## Marlboro BRF 010-1 (43) Traffic Signage Narrative

MARLBORO BRF 010-1 (43)  
TRAFFIC CONTROL SIGNAGE PLAN  
ROUTE 9 WEST OF PROJECT  
SHEET 1

# MARLBORO BRF 010-1 (43) TRAFFIC CONTROL SIGNAGE PLAN ROUTE 9 WEST OF PROJECT SHEET 5

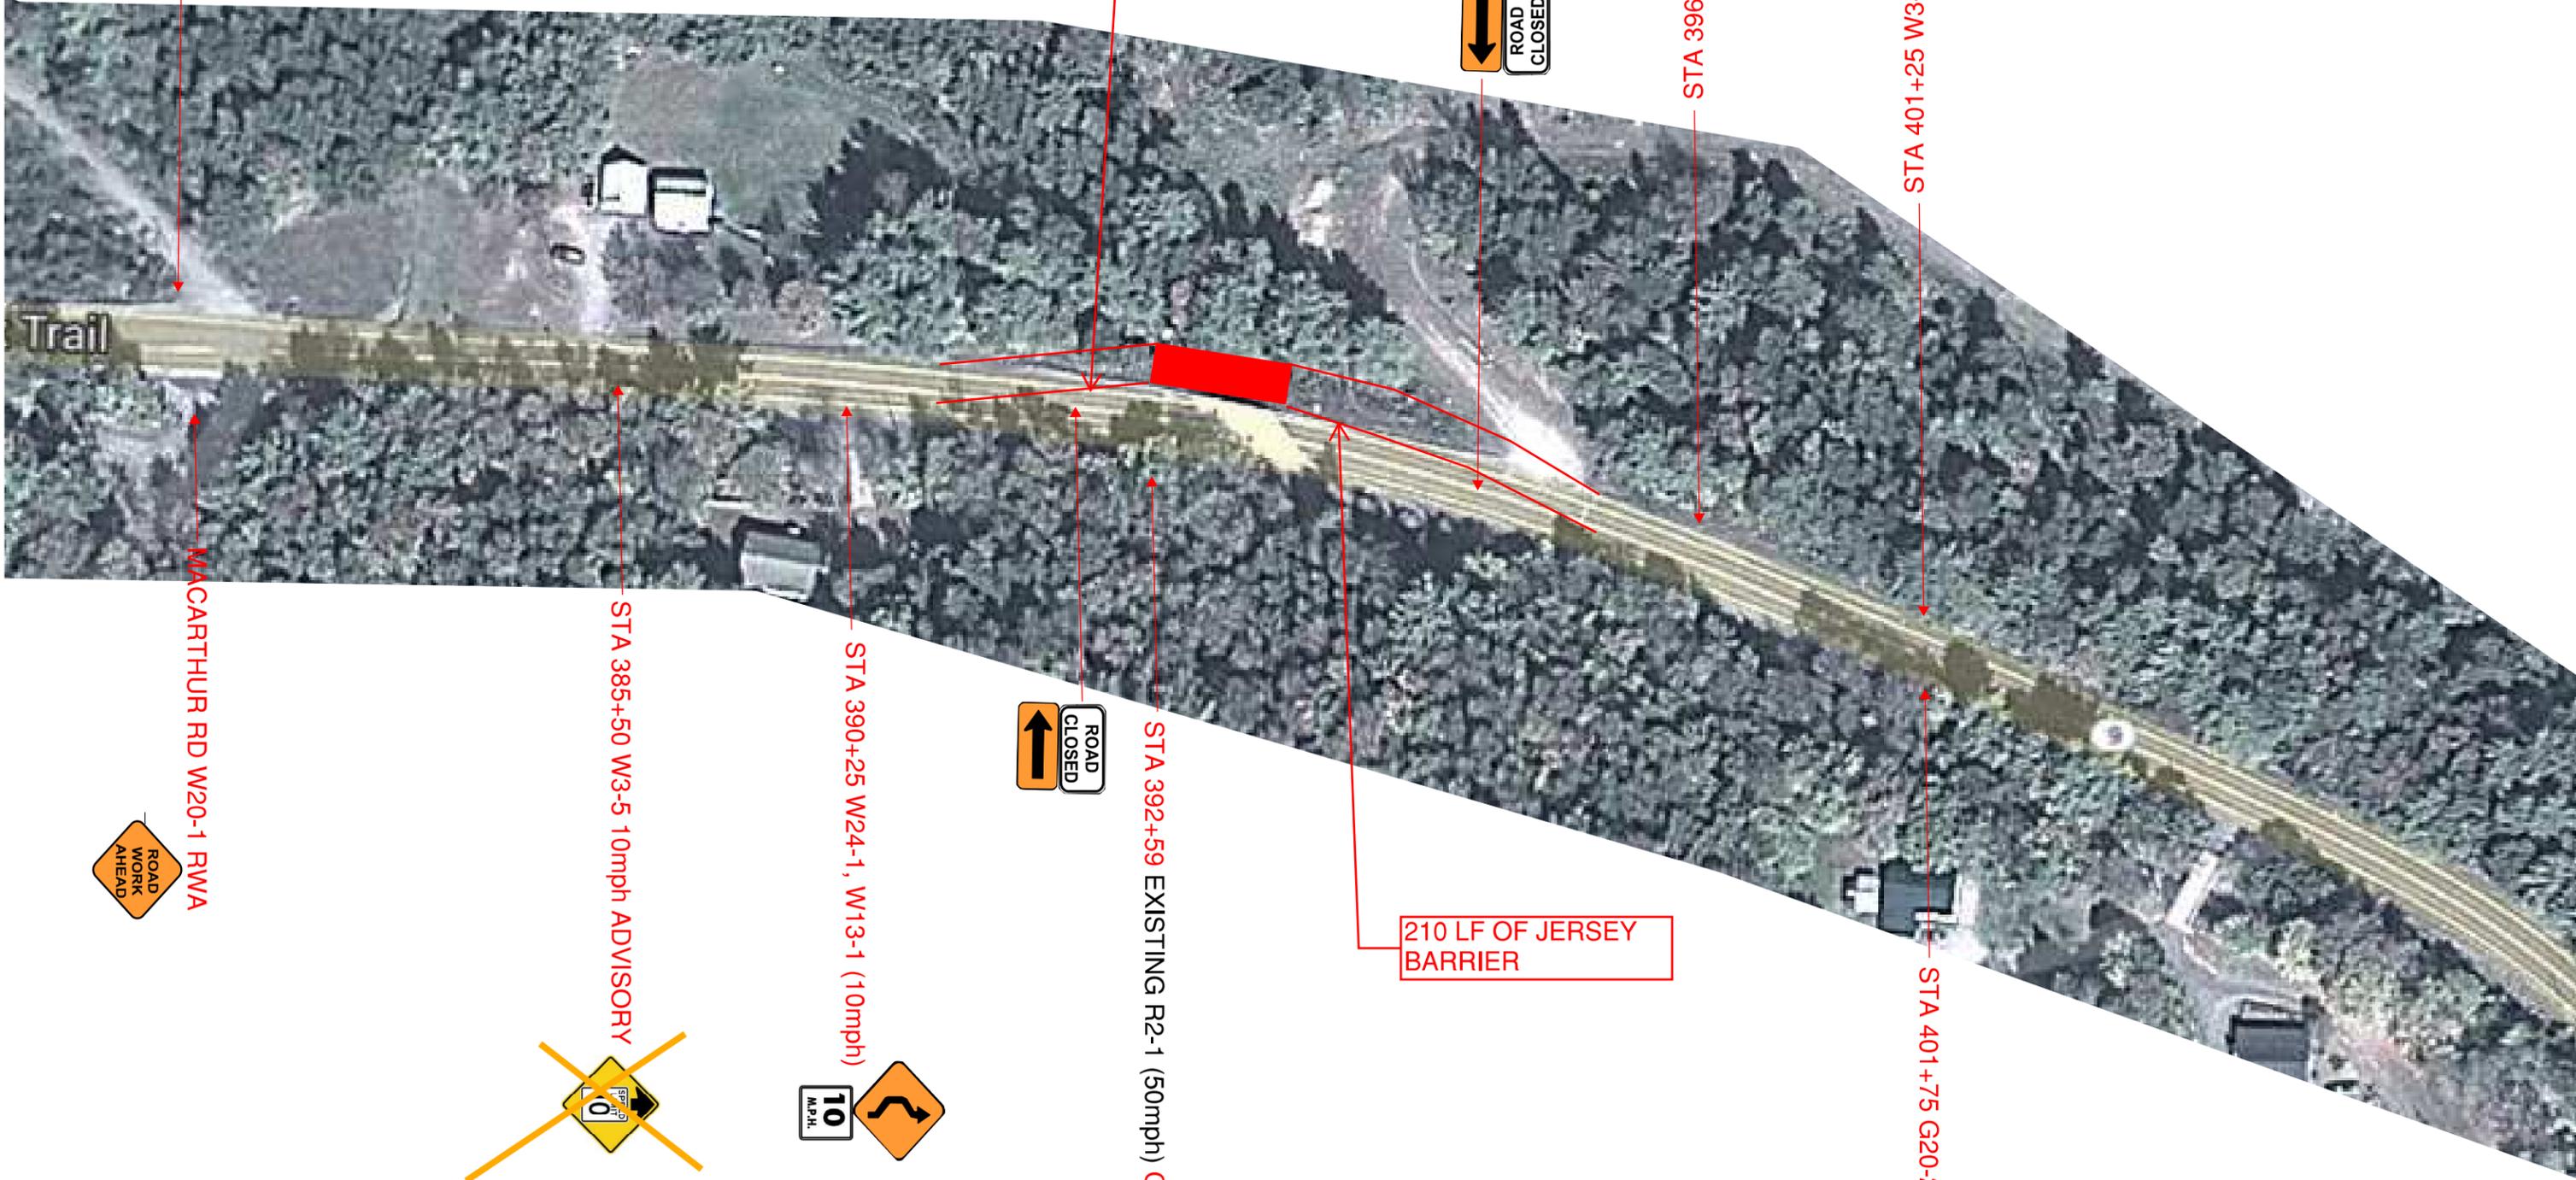
24x30": minimum;  
recommend 30x36"

MUTCD shows the  
"conventional road" size as  
24x18" (two lines of text)

24x30": minimum;  
recommend 30x36"

We will not allow this as a  
regulatory reduction; if  
intended as a lead sign  
for the advisory speed of  
10 mph ahead, the W3-5  
is not appropriate to use.

Incorrect sign  
shown; see  
MUTCD - this is a  
plaque that is  
installed under the  
regulatory speed  
limit sign - text is  
"FINES DOUBLE";  
size is 24x18"

List as W13-1P

This is an advisory speed  
plaque that is installed under a  
warning sign (like the W24-1);  
color is black on F/O is  
indicated (but not shown).

Not a known town highway, I believe this is private

see comment of previous page

Show placement of the W3-5 warning sign for each reduced zone ahead.

Need an End Road Work on Hamilton Road
